13.10.93

Resuscitation block

FACSIMILE MEMO

Re your fax 7191

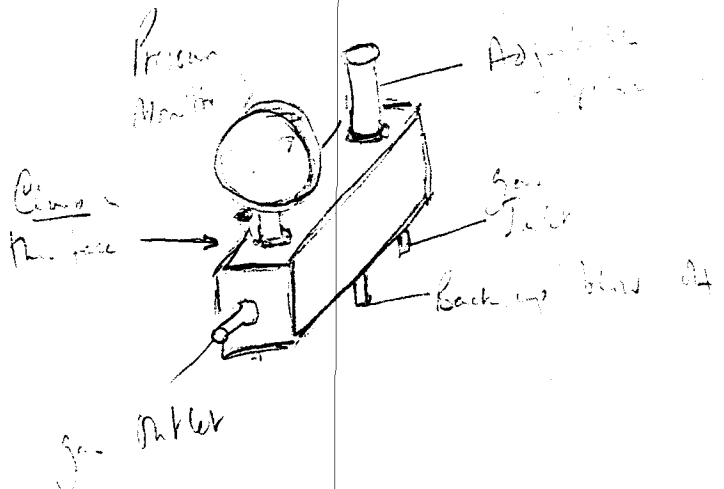
For my particular purpose I would need a vertically mounted pressure gauge as I will be using the blocks at eye level (See sketch below). Eventually we will be needing at least 12 blocks.
